**New Castle Planning and Zoning Commission Special Virtual Meeting
Wednesday, February 23, 2022, 7:00 p.m.,**

Update to the Public Works Manual Regarding Street Design Standards

Public Works Director John Wenzel reviewed the proposed changes to the Public Works Manual which is attached to these minutes as exhibit "A".

RESIDENTIAL STREET 56'-0" ROW SECTION	
TOWN OF NEW CASTLE	
NOT TO SCALE	DWG: ST-10

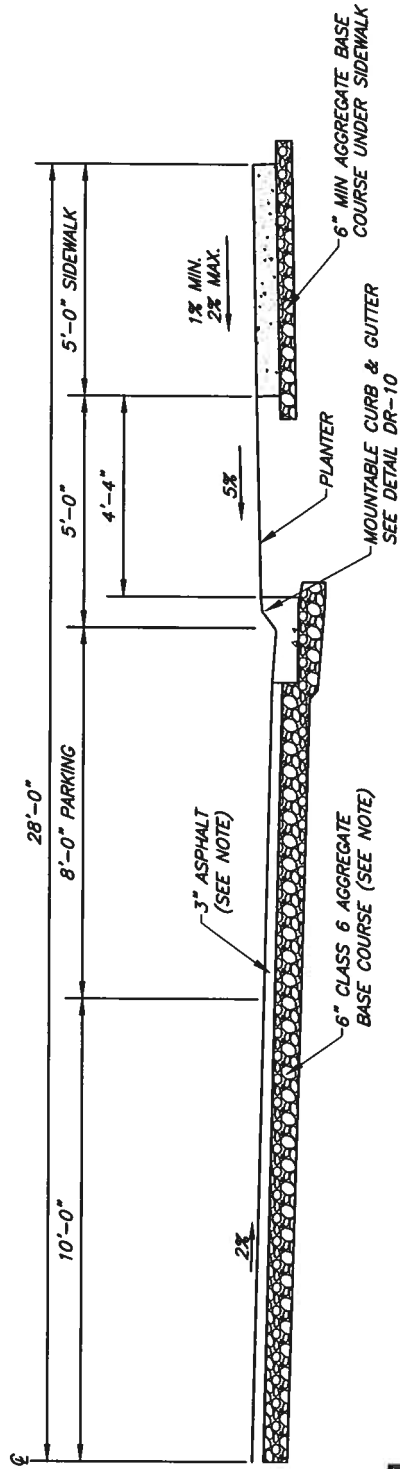
Director Wenzel said he was suggesting a wider right-of-way for local residential streets shall have a minimum right-of-way of fifty six feet (50') (56'), with a minimum paved portion of thirty-six feet (36'), measured flow line to flow line;

Director Wenzel said the extra six feet would allow for the separated sidewalks. Separated sidewalks are important because it provided snow storage and it also allowed for multiple forms of transportation. People were more likely to get out and they felt safer if there was a separation between the sidewalk and vehicle traffic.

3. Local residential streets shall have a minimum right-of-way of fifty six feet (50')(56'), with a minimum paved portion of thirty-six feet (36'), measured flow line to flow line;

**COLLECTOR STREET
SECTION**

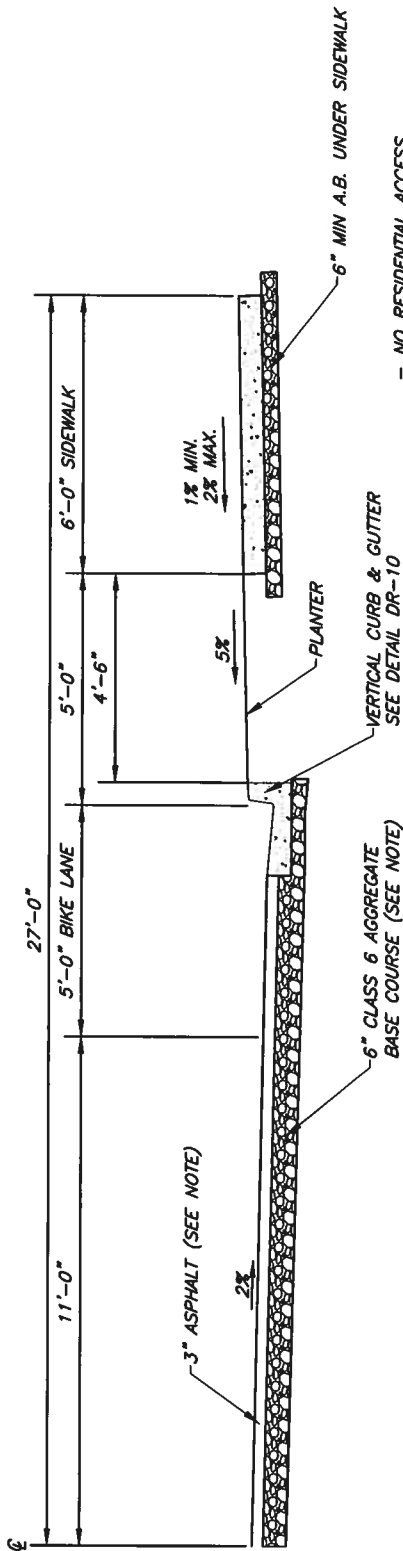
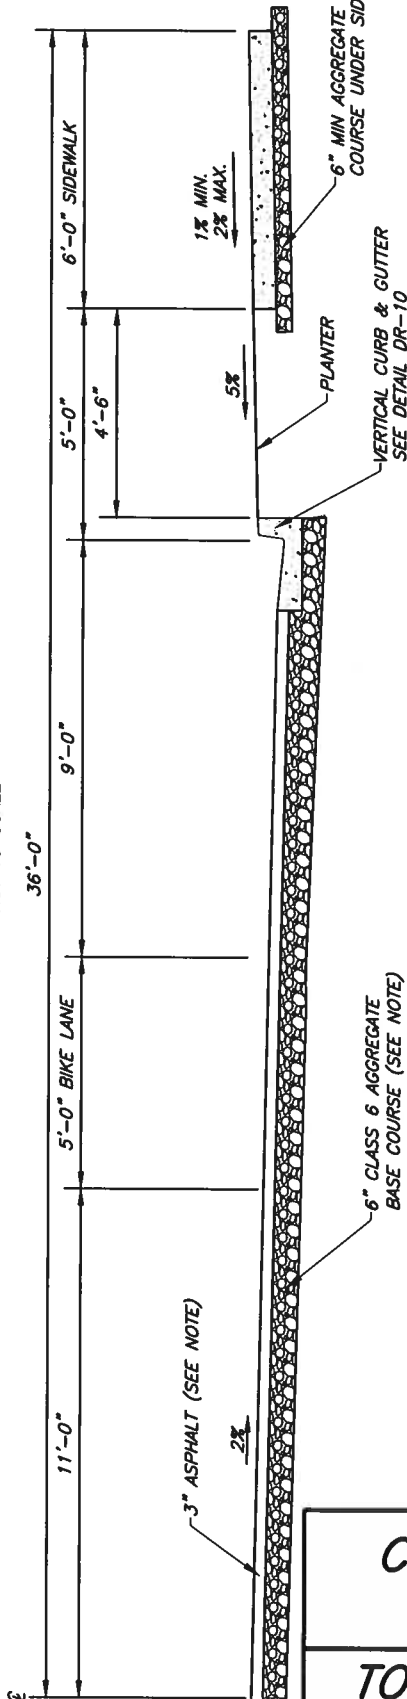
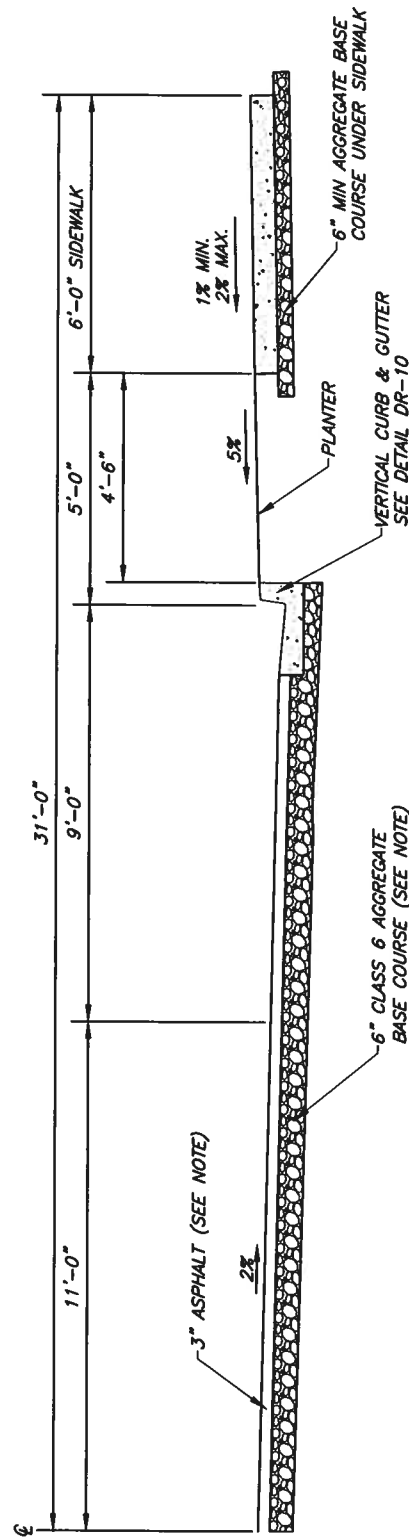
Director Wenzel said he wanted to define and have clarity for what was a "Collector Street". Collector streets shall have a minimum right-of-way width ranging from fifty two feet (52') to seventy feet (70') of eighty feet (80'), with a minimum paved portion, measured from flow line to flow line, ranging from twenty six feet (26') to fifty feet (50'), of forty seven feet (47'); Collector street right-of-way size will be determined by the Collector Street Cross Section recommended by the Town Engineer and approved by the Planning Commission.

2. Collector streets shall have a minimum right-of-way width ranging from fifty two feet (52') to seventy feet (70')~~of eighty feet (80')~~, with a minimum paved portion, measured from flow line to flow line, ranging from twenty six feet (26') to fifty feet (50'), ~~of forty seven feet (47')~~; Collector street right-of-way size will be determined by the Collector Street Cross Section recommended by the Town Engineer and approved by the Planning Commission.
